## DESIGN EXCEPTION #DE 9-05

RE: Intersection Radii – 27 Road & Club Court.

SUBJECT: **TEDS Exception**

Project/Development: **Curb, Gutter and Sidewalk along 27 Rd north of Safeway improvements to Club Ct.**

12th STREET AND CLUB COURT  
CURB, GUTTER AND SIDEWALK PLAN

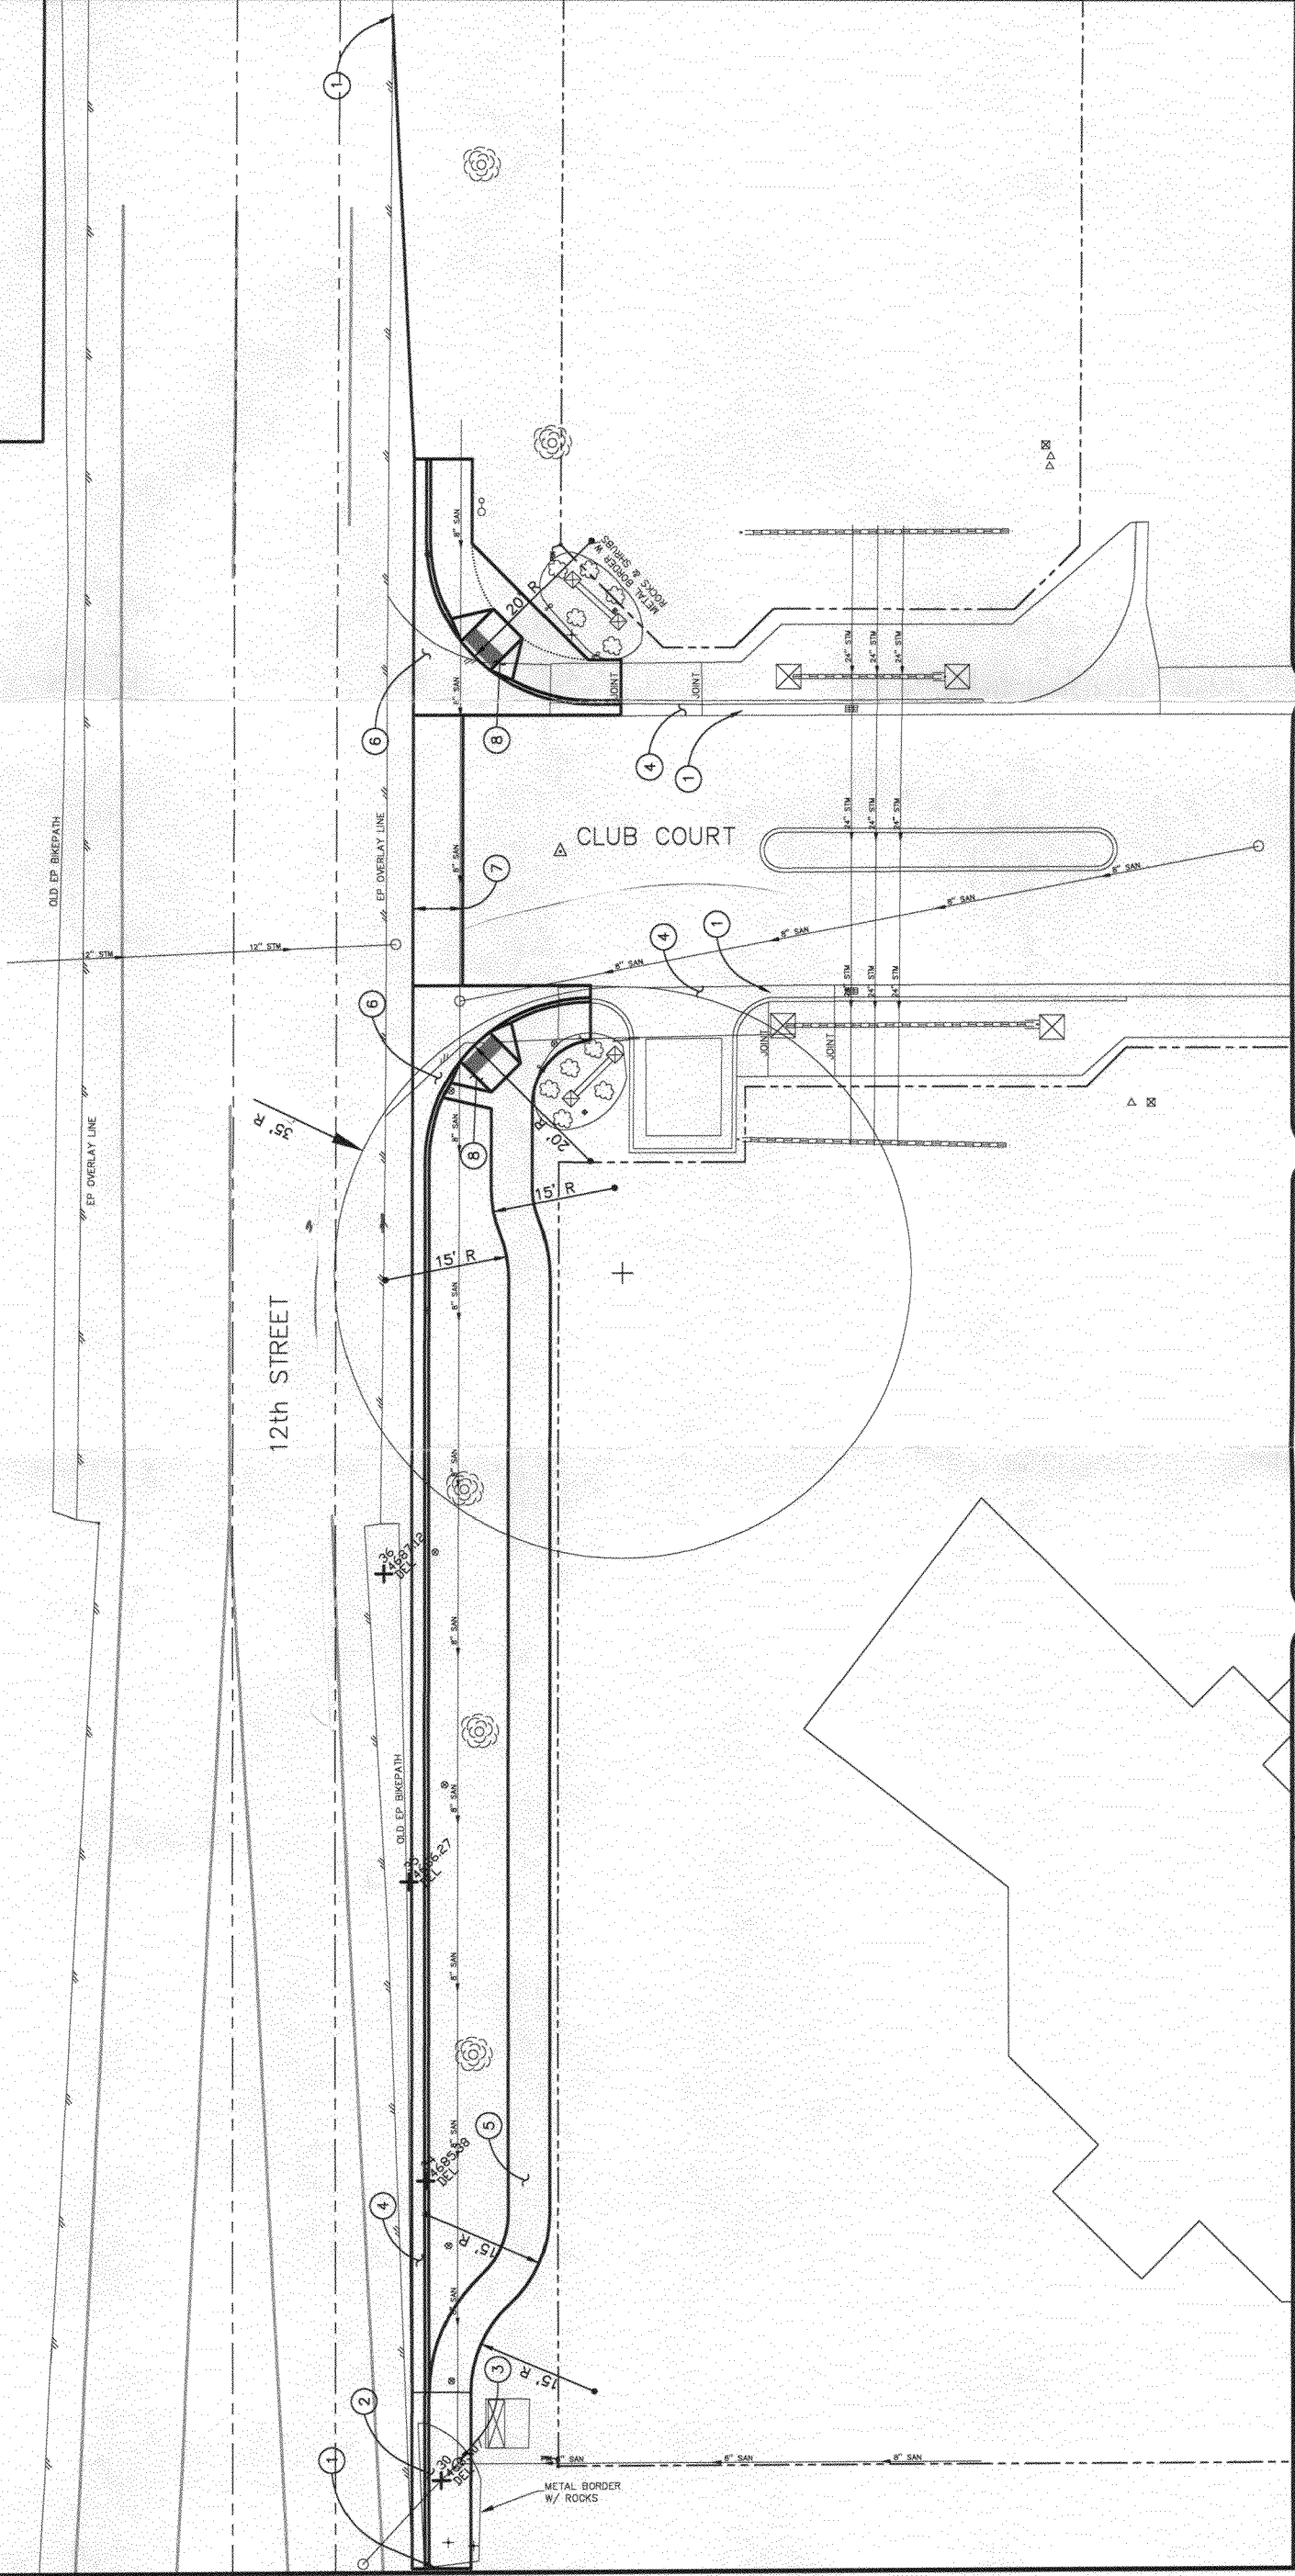
- 1. Will the exception compromise safety?**  
Staff does not believe the proposed configuration will create future safety issues. The project proposes to increase pavement width on 27 Road to include a 4 foot bike lane. The net effect will be to create a turning radius of approximately 35 feet (see attached plan).
- 2. Have other alternatives been considered that would meet the standard?**  
The alternative of removing existing signage & landscaping and modifying the private concrete and pavement improvements could be accomplished to meet TEDS.
- 3. Has the proposed design been used in other areas?**  
There are examples of developed areas that do not meet this standard.
- 4. Will the exception require CDOT or FHWA coordination?**  
No

Description of exception: This intersection is part of the new installation of Curb Gutter and Sidewalk along the east edge of 27 Rd from the north end of the Safeway improvements at 681 Horizon Dr. North to Club Ct. The TEDS exception being requested is to construct a flow line radius of 20 feet as opposed to the minimum for a Local Residential intersecting a Collector of 25 feet. This exception is being sought in order to avoid conflicts with existing entrance signs, utilities and landscaping.

Justification: Club Ct. provides access to a gated residential subdivision with very little truck traffic. The existing half street section is 16' wide, a 12' driving lane with a 4' bike lane. By installing the new curb and gutter, in alignment with the existing, we will be widening the road section to 22'. The extra width provided by the road widening serves to increase the actual turning radius to 35 feet.

The committee approved the exception requested with the following modifications:

1. The radius on the south side be designed to be as long as possible. If the removal of portions of the existing concrete and asphalt increases the ability to extend the radius, those modifications should be included in the project.
2. The Radius on the north side should meet the TEDS standard of 25 feet.
